802.3dj D3.0

Comment Resolution

Electrical Topics

Vf (Preset 1) –vs- Rpeak

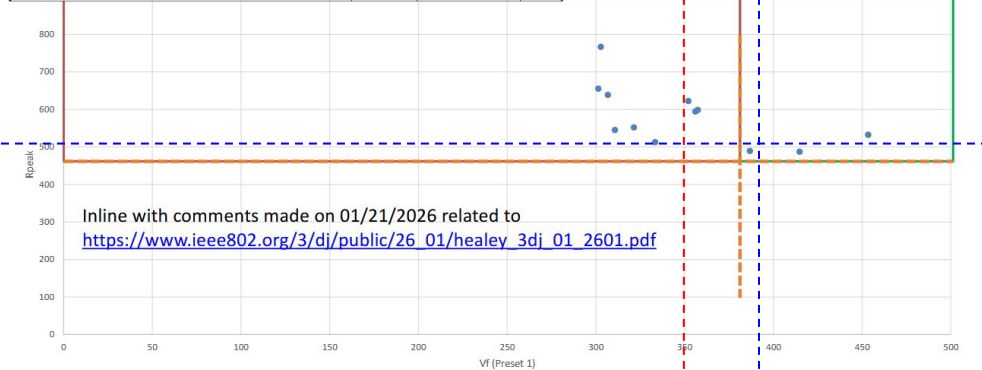
Vf minimum value of .389V still fails the majority of early designs.

The interop report out:
https://www.ieee802.org/3/dj/public/26_01/calvin_3dj_01a_2601.pdf Page 23 shows 9 out of 12 modules failing Vf. We either need to review the measurement methodology in Vf (which is not new) or consider further reduction of the Vf values to 350mV.

Blue overlay lines show (approximately) the new limit values proposed by comment #175.
 Red overlay line shows the new limit value proposed by comment #277.

PROPOSED REJECT.
 The v_f specification is an important component of the COM analysis that supports the loss budget of 32 dB for C2M applications. Reducing the minimum v_f would undermine this analysis and prevent interoperability with worst-case hosts.
 The information in the referenced presentation does not justify reducing the v_f limits. It shows that some of the tested modules met the requirements. Devices that failed the requirements might have not been configured correctly or might be non-compliant.
 [Editor's note: changed clause/subclause/page from 179D/179D.6.3/821 to 176D/176D.6.5/822]

Figure 179B-3—Mated test fixtures common-mode to differential-mode insertion loss requirements

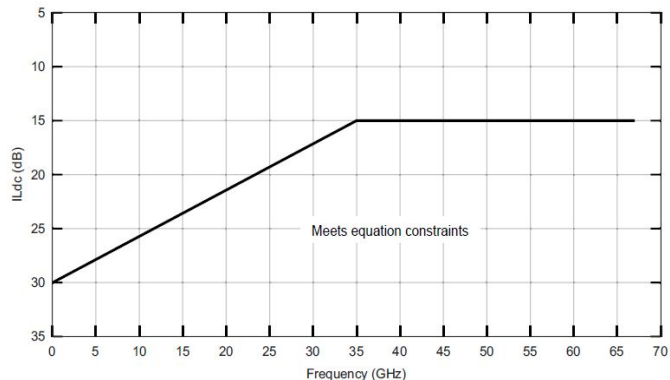
Intrapair skew has not been directly considered for the MTF. Although intrapair skew is included in the computed differential mode to differential mode insertion loss, the effect of skew has not been explicitly specified. Common mode to differential mode insertion loss does contain elements of skew. An either or specification for SCMR_CH should be added to control MTF intrapair skew.

Replace line 3 with:
 The common-mode to differential-mode insertion loss of the mated test fixtures measured in both directions shall meet Equation (179B-6) as illustrated in Figure 179B-3. or the channel signal to common-mode ratio (SCMR_CH) shall exceed 12 dB using the procedure described in 179.11.7.

The comment suggests adding a minimum SCMR_CH of 12 dB as an alternative to the frequency mask of Equation 179B-6.

Replace line 3 with:
 "The mated test fixture shall comply with at least one of the following conditions:
 -- The common-mode to differential-mode insertion loss of the mated test fixtures measured in both directions meets Equation (179B-6) as illustrated in Figure 179B-3.
 -- The channel signal to common-mode ratio (SCMR_CH) is greater than <x> dB using the procedure described in 179.11.7."

Figure 178A-2—Single-ended and mixed-mode S-parameters

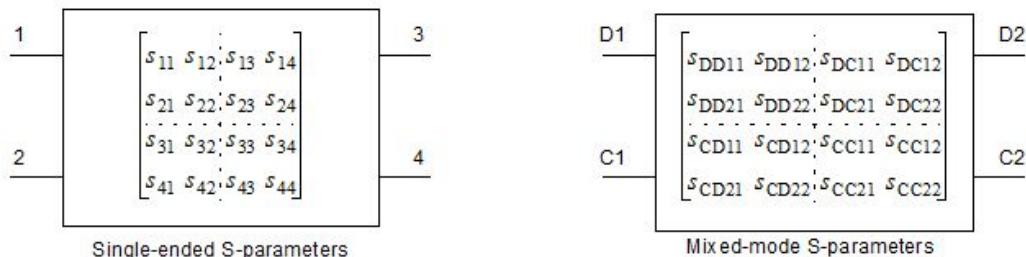
- Comment #153 proposes to add a definition of modal S-parameters to Annex 178A to support modal ERL definitions
- This is also covered [mellitz_3dj_02_2605](#), but the proposed definition seems incomplete and out of place
- Also, Annex 178A pertains to channels and modal ERL is also proposed for transmitters and receivers

- With regard to the definition of mixed-mode S-parameters, we usually try to avoid including extensive tutorial material in the standard
- However, it seem prudent to provide at least some rudimentary definition of the parameters subject to specification
- The text in the following slides is proposed to be used to address comments #153 and #154.

Figure 178A-2 illustrates 4-port single-ended S-parameters $S^{(s)}$ and the corresponding mixed-mode S-parameters $S^{(m)}$ at any given frequency. COM is computed using the differential-mode S-parameters which are taken from the upper-left quadrant of mixed-mode S-parameter matrix. Other mixed mode S-parameters may be used as the basis for other specifications.
